Zoning Staff Report

Case Number: ZC-26-048

Zoning Map Amendment

Proposed Use: Automated Car Wash

SHEET TITLE:
 CUP SITE PLAN

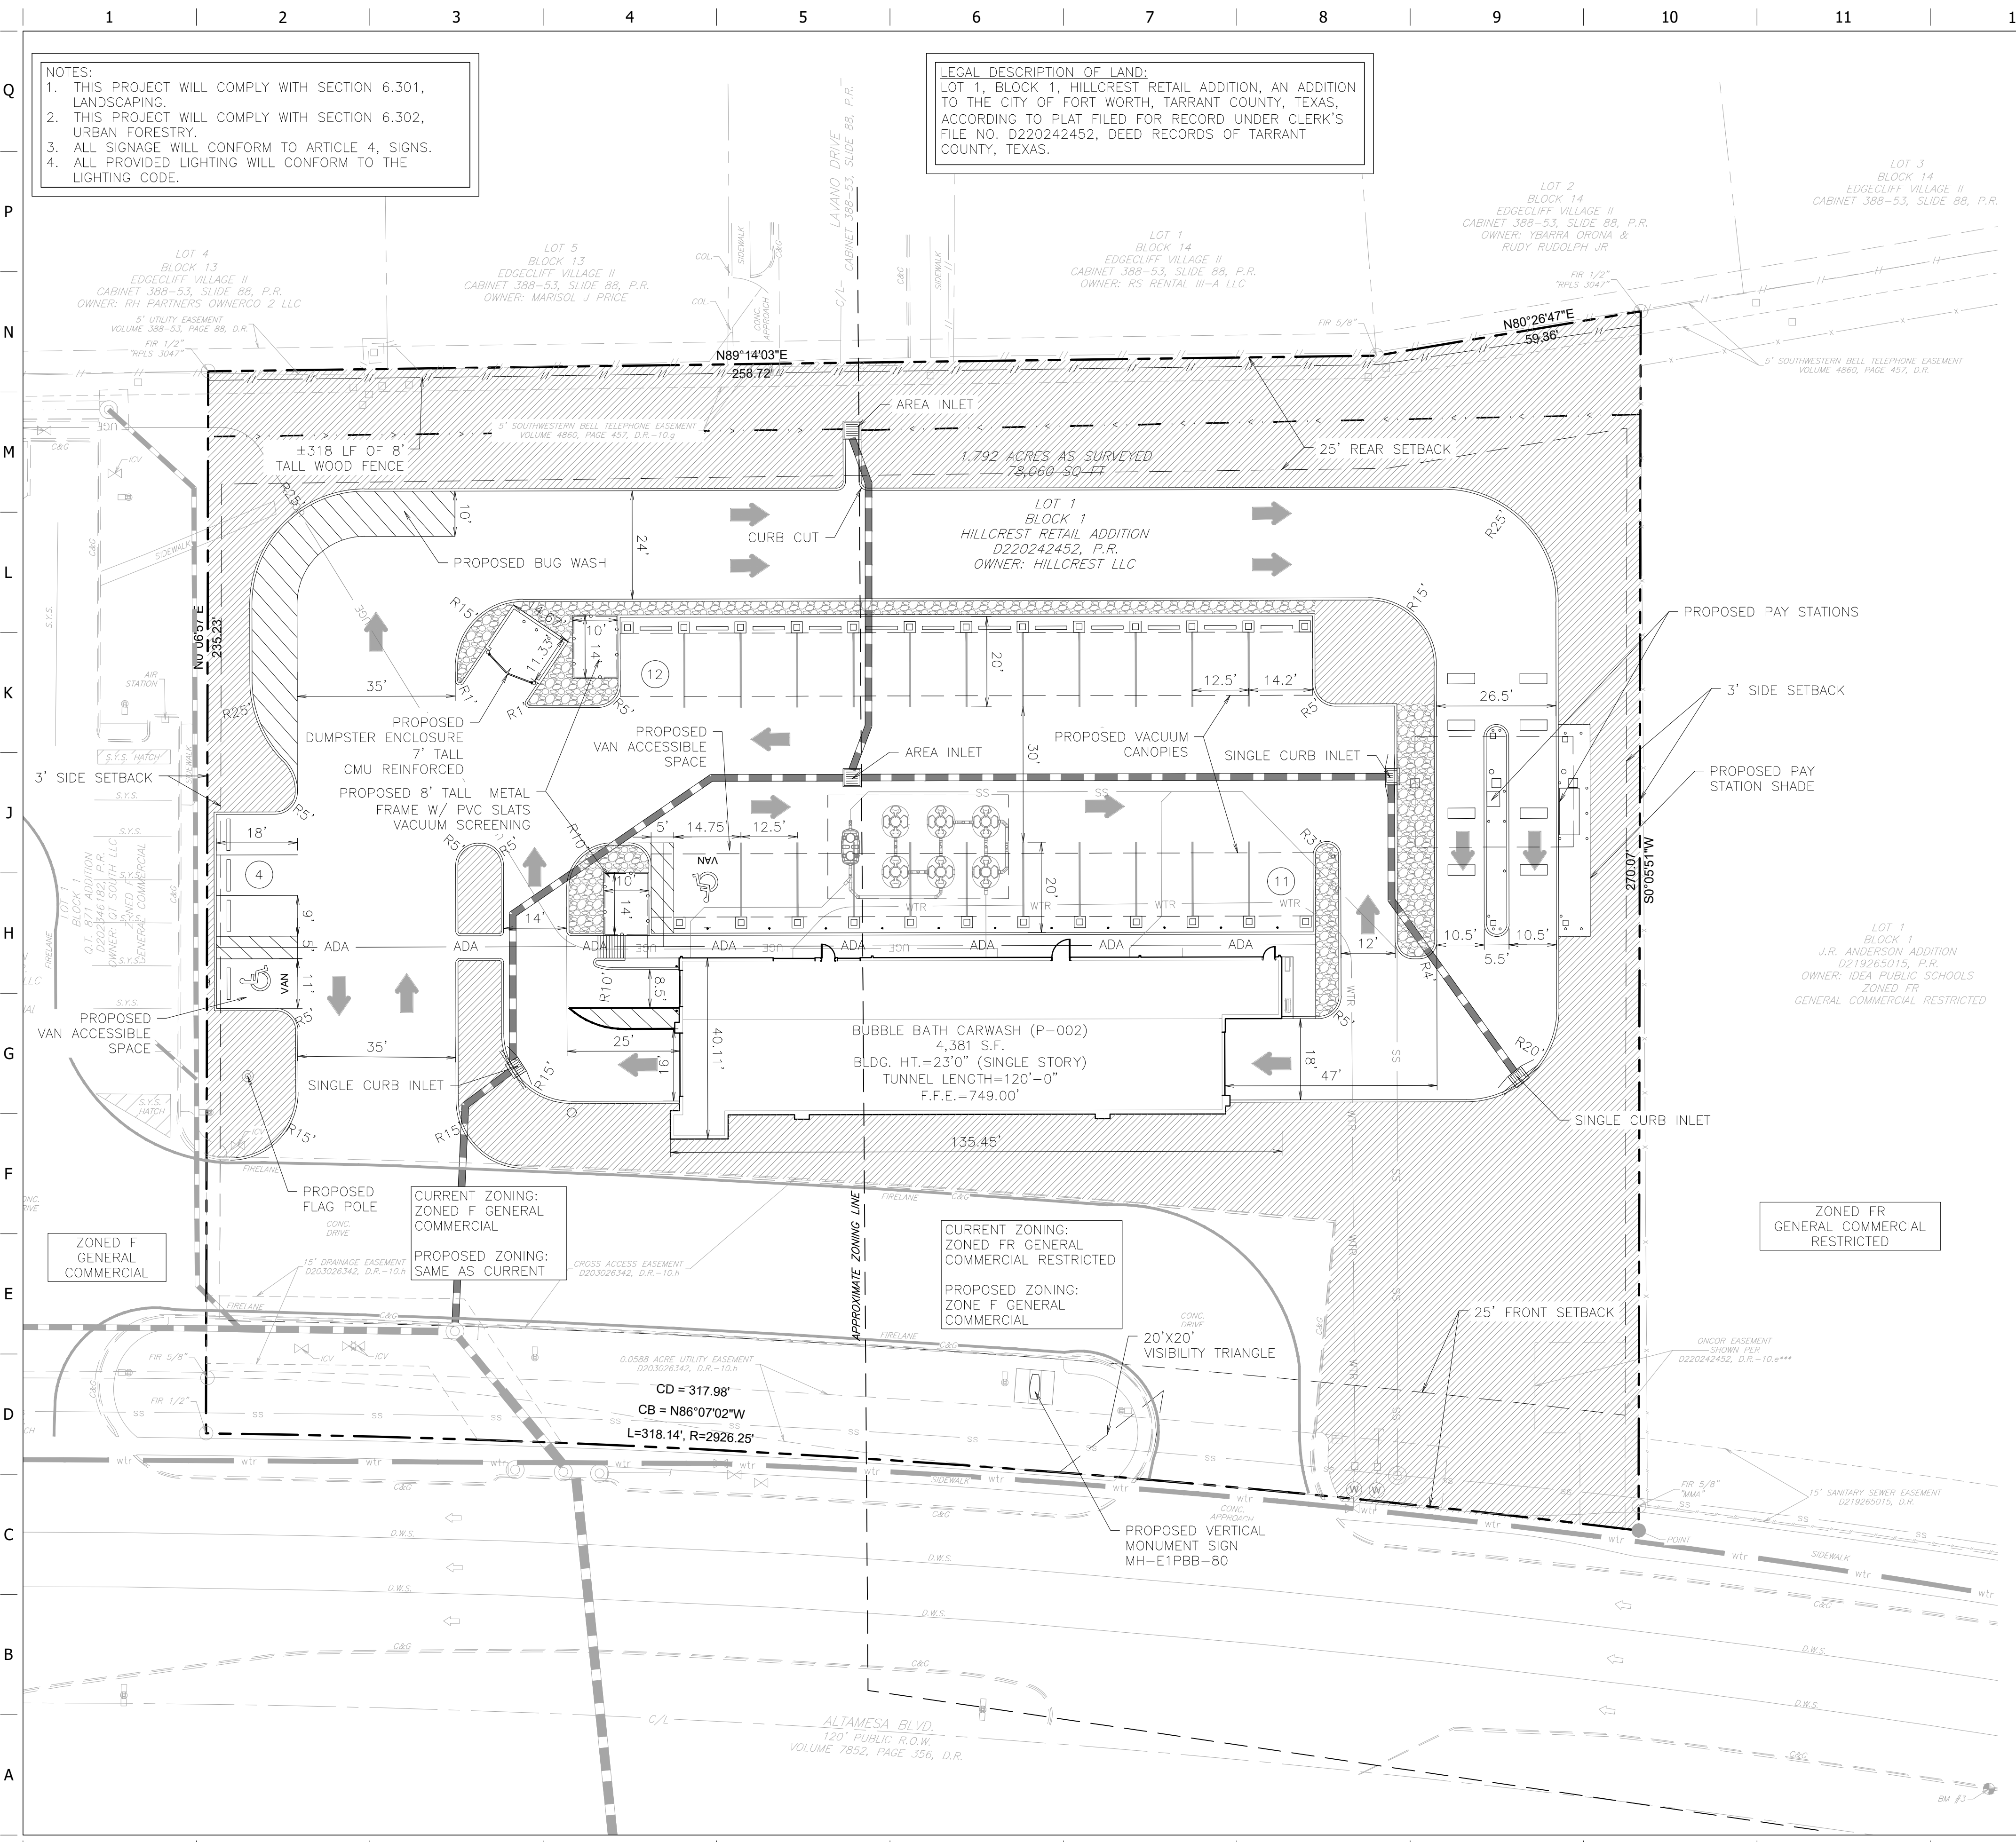
1. The site plan and all its details need to be clearly visible at any scale, instead of having uneven text.
2. Add the date of preparation.
3. Add the current owner's name, address, and telephone number.

4. Update the zoning case number to ZC-26-048 in the lower righthand corner.
5. The underground utilities can be moved to another sheet if this sheet becomes too cluttered.

6. Update the proposed building's use to Automated Car Wash, instead of the brand name.
7. Add the requested zoning district of CUP Overlay.
8. Dimension the pay station shade cover and have the arrow pointing to the actual structure.

9. Label the overhead doors on the car wash building.
10. Correct the building height on the site plan to match the building height maximum on the elevations.

11. Add the height of the flag pole.
12. EFIS is not considered a durable material. Please swap this out for masonry, porcelainized steel, baked enamel steel, or an equivalent material.

13. The PVC slats on the vacuum screening are not considered a durable material. Please swap this out for masonry, porcelainized steel, baked enamel steel, or an equivalent material.

14. The pay station and vacuum canopies must meet the same building material standards. Please include building elevations of these items.
15. Instead of the manufacturer, please list the specific building materials of each item, including all windows and pedestrian doors.

16. Remove all signage shown attached to the building, as the site plan notes state the project will comply with Sec. 6.4.
17. Note that 4 cars can be contained on the wash line at one time.

18. The northwestern "F" portion of the site has a 35-foot setback, instead of the 25-foot setback shown.
19. What exactly happens at the "proposed bug wash" area? Are any chemical solutions used here?

20. Provide the parking calculations at 5 parking/vacuum spaces per car on the wash line. Add a note detailing the difference between the required parking and provided parking.

21. Add a note that the site will be required to plant 2 additional trees because the site is over-parked by 13 spaces.
22. The second ADA parking space should not be on the other side of the main drive aisle, as this is not a safe route. Move it to be on the same side as the building.

23. Add the width of the Cross Access easement.
24. What is the second driveway on the west exit side used for?
25. Please be aware the washed granite areas do not count towards your landscaping requirement.

26. Will the front "island" with the monument sign be landscaped? If so, please show the landscaping pattern. If not, it is not readily apparent how the site would meet the required landscaping in front of the building.

27. Label the land use and zoning classifications of the immediately adjacent properties to the north. Do not ghost this text.
28. The bike rack location is not clear.

29. The site plan does not show how the parking lot would meet the 40% canopy coverage.
30. Show and label the ground mounted air conditioners. If no air conditioners will be ground mounted, add a note stating where they will be located.
31. Comments may be modified or added when additional information is provided.
